Access Compliance Report Public Rights-of-Way (Curb Ramps)

Main Street: BRITTANY_WOODS_DR Cross Street: TIFFANY_PL Location: E

ADA ID: RPRK211014154124 Ramp Type: Type 1 - Perpendicular Diagonal Initial Pass/Fail: Pass Overall Compliance: No Severity Score: 2

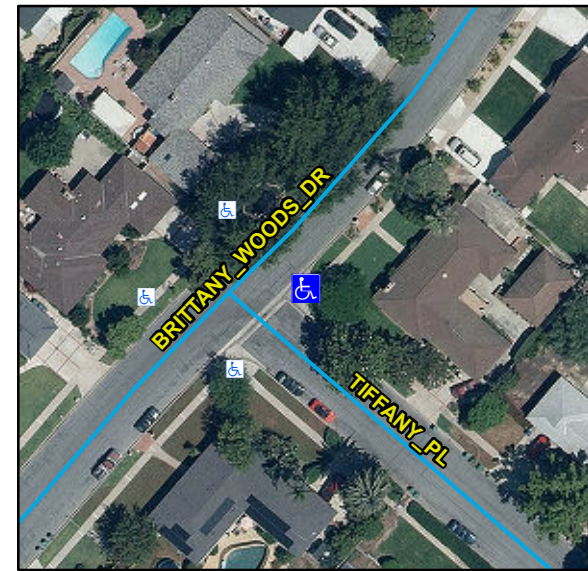
Compliance	Description	Data	Compliance	Description	Data
N/A	Ramp Length (in)	116	N/A	Flare Type LT	
Yes	Ramp Width (in)	48			Sloped
Yes	Ramp Run Slope (%)	5.9	Yes	Flare Slope LT (%)	3.9
Yes	Ramp Cross Slope (%)	0.1	N/A	Flare Traversable LT	Yes
N/A	Landing Present	Yes	N/A	Flare Type RT	
N/A	Landing Length (in)	48			Sloped
Yes	Landing Width (in)	48	Yes	Flare Slope RT (%)	3.5
Yes	Landing Run Slope (%)	1.7	N/A	Flare Traversable RT	Yes
Yes	Landing Cross Slope (%)	0.2	Yes	DWS Provided	Yes
N/A	Landing Movement Obstructed?	Yes	Yes	DWS Contrast	Yes
	Landing Movement Type	Curb	Yes	DWS Length (in)	36
N/A	Landing Shared	No	Yes	DWS Full Width	Yes
N/A	Clear Space	Yes	Yes	DWS Offset Left (in)	0
N/A	Clear Space To Crosswalk (in)	48	Yes	DWS Offset Right (in)	N/A
N/A	Marked Crosswalk 1	No	N/A	Marked Crosswalk 2	No
	Crossing 1 Direction	NW		Crossing 2 Direction	SW
	Marked Crosswalk 1 Width (in)	N/A		Marked Crosswalk 2 Width (in)	N/A

Remove & Replace Landing.
